February 12, 2026  
Project No. 20210371E001

Subject: Response to Third-Round Building Plan Review Comments  
Barnabie Point Project  
Herzl-Ner Tamid Conservative Congregation  
3700 East Mercer Way  
Mercer Island, Washington

Associated Earth Sciences, Inc. (AESI) has reviewed the third-round building plan review comments provided by the City of Mercer Island. The geotechnical-related comments are restated below followed by our response.

Shoring Wall Slot Cut Schematic

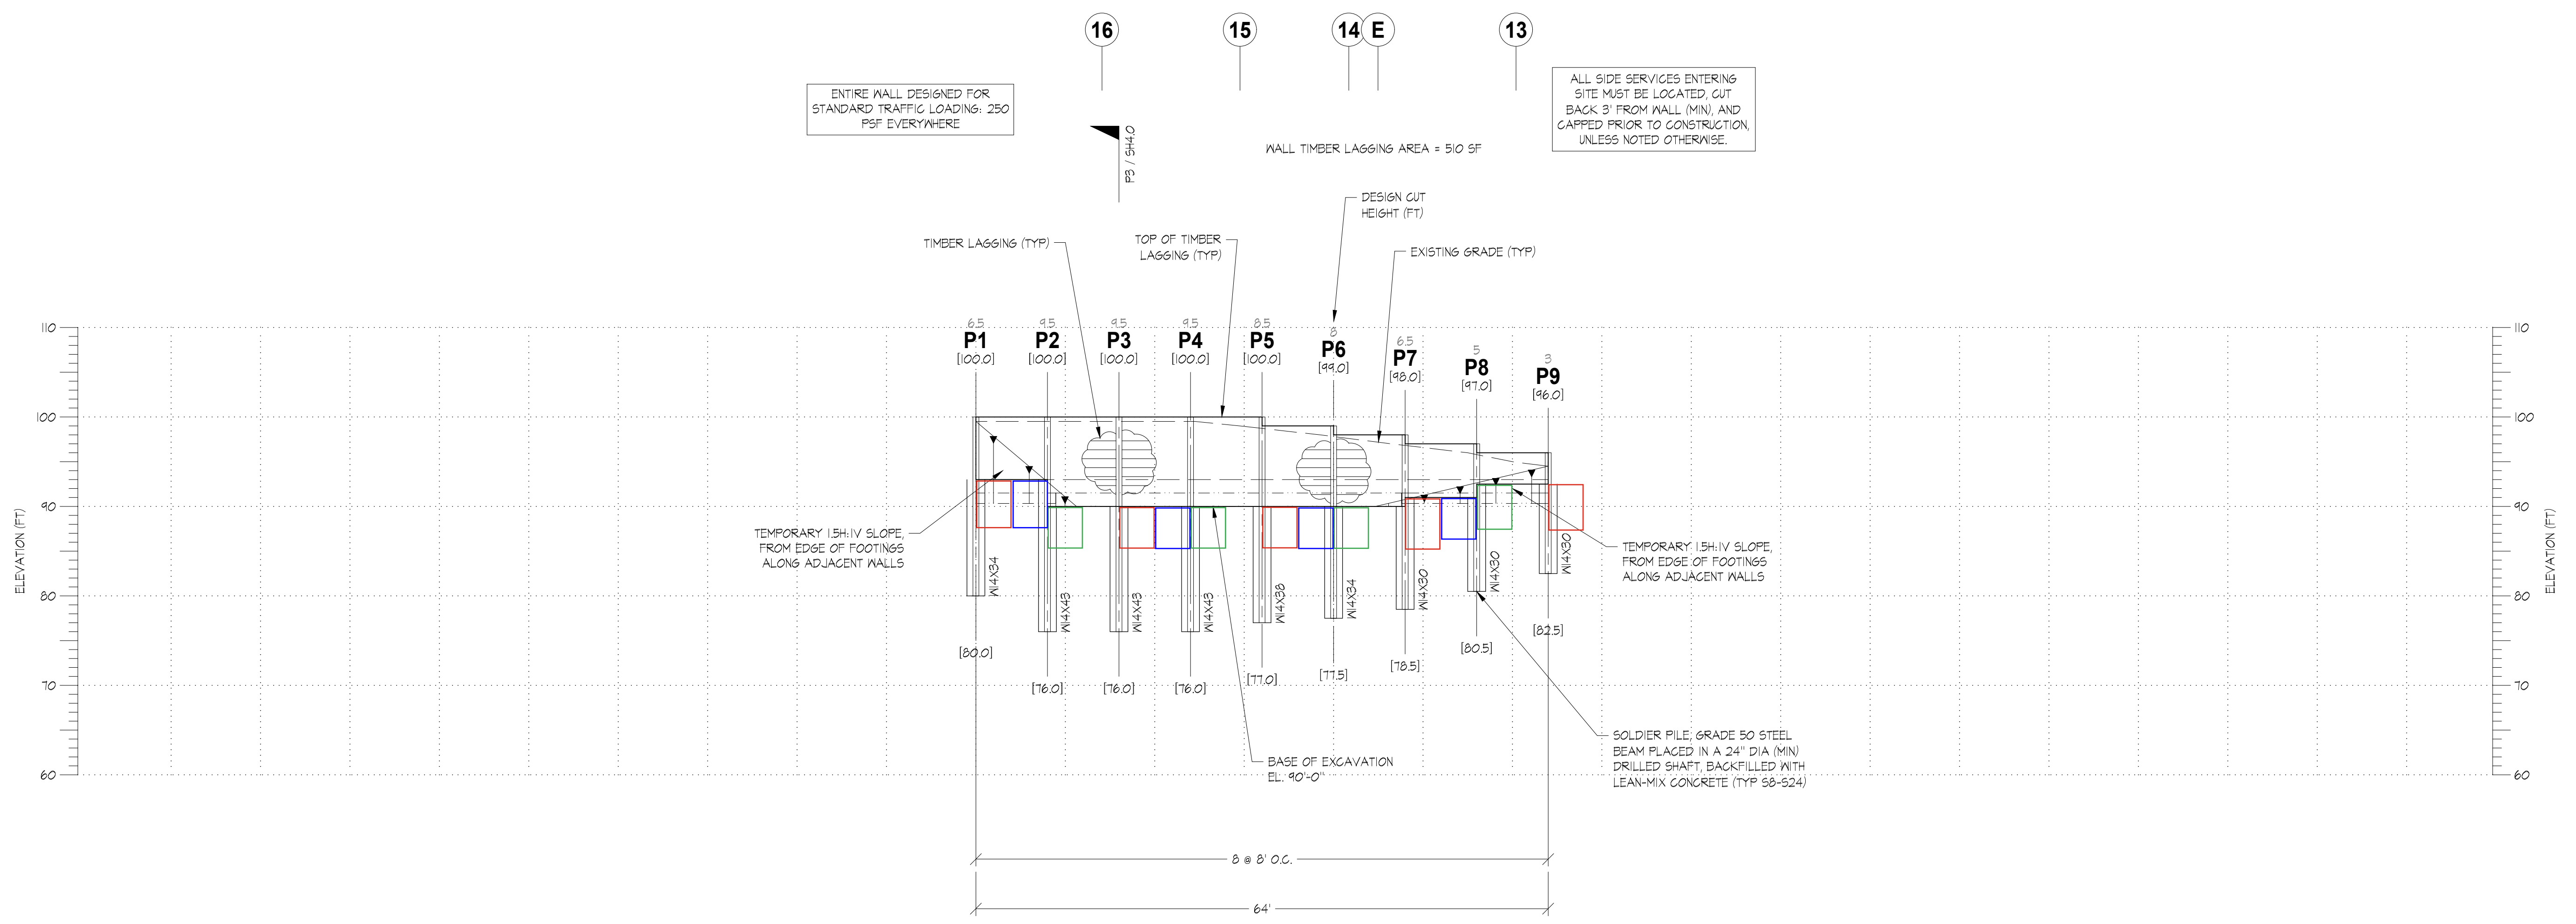
*Please revise the extent of excavation to accommodate a BOE of elevation 85 feet as expected by the geotechnical engineer of record.*

*The BOE is anticipated to range from elevation 88 to 85 feet. Please revise shoring wall design to accommodate this anticipated overexcavation. The geotechnical engineer of record indicated a maximum retained wall height of 16 feet in their temporary shoring wall design recommendations letter dated November 14, 2025. Please submit revised plans and calculations for review.*

The retained height of the shoring wall during foundation and basement level construction will be limited to approximately 10 feet as indicated on the submitted shoring wall plans, as the maximum excavation depth needed to reach design bottom of footing (BOF) is at elevation 90 feet. The maximum overexcavation depth to elevation 85 feet is a conservative estimate for earthwork and foundation contingency planning. Rather than revising the shoring wall design to accommodate a conservative BOE of 85 feet along the entire wall alignment, AESI recommends that any required overexcavation be completed in “slot cuts” as determined in the field by an AESI representative at the time of foundation construction.

For this project, a slot cut is defined as the excavation of a narrow trench directly below the building footing to reach suitable native bearing soils and immediately backfilling the trench with controlled density fill (CDF). Depending on the variability in depth to reach suitable native soils below the design BOF, multiple slot cuts and strategic sequencing may be needed along the shoring wall alignment.

Attached to this letter is a schematic of the recommended slot cut sequencing (see red, blue, and green boxes which represent the slot cut trenches). This schematic represents a worst-case scenario where the entire shoring wall alignment requires overexcavation. Each slot cut would have a maximum width of 4 feet, and the edge of each slot cut would start at the center line of a soldier pile. The slot cuts should be limited to a maximum depth of 6 feet. Any loose soils remaining at the base of the trench can be compacted in place with a vibratory plate compactor attached to the excavator arm. The position of each slot cut as shown in the schematic was selected so that each soldier pile will have only partial removal of passive resistance within the limits of the slot cut excavation, and each series of slot cuts (red, blue, and green boxes) are positioned every other pile to minimize disturbance to the overall shoring wall system.

1. Excavate the red slot cuts first, as needed, and immediately backfill the slot cuts with CDF. Confirm the CDF achieves a minimum unconfined compressive strength of 100 pounds per square inch (psi) before proceeding to Step 2.
2. Excavate the green slot cuts next, as needed. Follow the same CDF procedure as Step 1.
3. Excavate the blue slot cuts next, as needed. Follow the same CDF procedure as Step 1.
4. Excavate all remaining slot cuts and immediately backfill with CDF.

We have coordinated with Ground Support PLLC on the slot cut procedure described above and understand that the shoring wall design has been revised to reduce the passive pressure to 200 pounds per cubic foot (pcf) from elevation 90 to 85 feet (neglecting the upper 2 feet below BOF), and that all pile lengths have been increased by 1 foot to accommodate potential slot cuts. From a geotechnical standpoint, it is AESI’s opinion that no additional revisions to the

shoring wall design are necessary provided that the slot cut procedure and sequencing described in this letter are properly followed under continuous observation by AESI.
